Docket Item #23
SPECIAL USE PERMIT #2003-0115

Planning Commission Meeting
June 1, 2004

ISSUE: Consideration of a request for a special use permit to construct a single family on a substandard lot and a parking reduction.

LOCATION: 301 Laverne Avenue

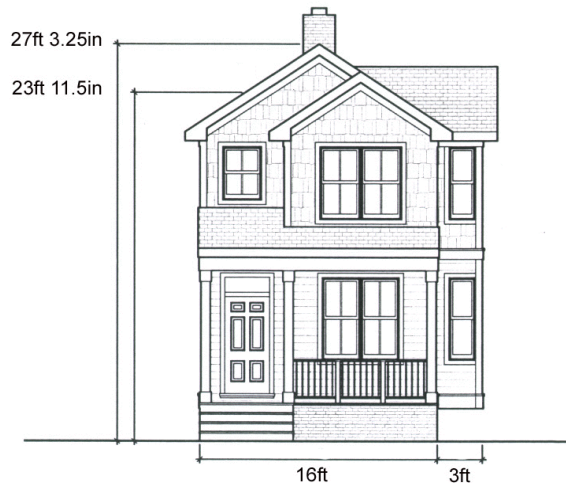
The zoning ordinance recognizes that building a house on a lot that is not as large as the zone may require modifications of the standard zoning rules. Staff can support modifications when they help create development in a way that is more consistent with its immediate surroundings and with the established pattern in the neighborhood than strict compliance with the zoning ordinance would allow. Staff found the substandard lot case being heard at 2001 LaGrande Avenue (SUP#2004-0020) to be an example of the point. In the subject case, however, although some of the modifications are supportable in the abstract, others show how difficult it is to build the applicant's proposed house on this very small lot.

The applicant in this case surveyed the front setbacks of a number of corner properties in the vicinity of the subject property and found that the majority have setbacks less than what the zoning currently requires. The area was built, in the main, prior to the adoption of the current zoning requirements, so the applicant's findings are not surprising. In addition, the surveyed properties are larger than the subject parcel, and in some cases are developed with semi-detached dwellings, discounting their relevance to the requested modifications for the subject property. However, staff agrees that as to the front setback requirement on Laverne, the proposed modification is desirable so as not to have a new house out of character with the others nearby. On the Turner Street frontage however, the small setback (11 feet to the building wall and only eight feet to the large bay windows) is problematic, as it allows a large and long structure (60' long) very close to the street, and completely out of character with the setback of the house behind it.

Staff does not object to a vision clearance modification, in that the streets affected are neighborhood, residential streets, with relatively slow traffic, and because there is a stop sign at Turner Road.

Finally, staff cannot support the rear yard paving modification because the size and location of the house leaves a small side (rear) yard, the parking provided there is not even sufficient to meet zoning requirements and the paving and curbcut require removal of trees.
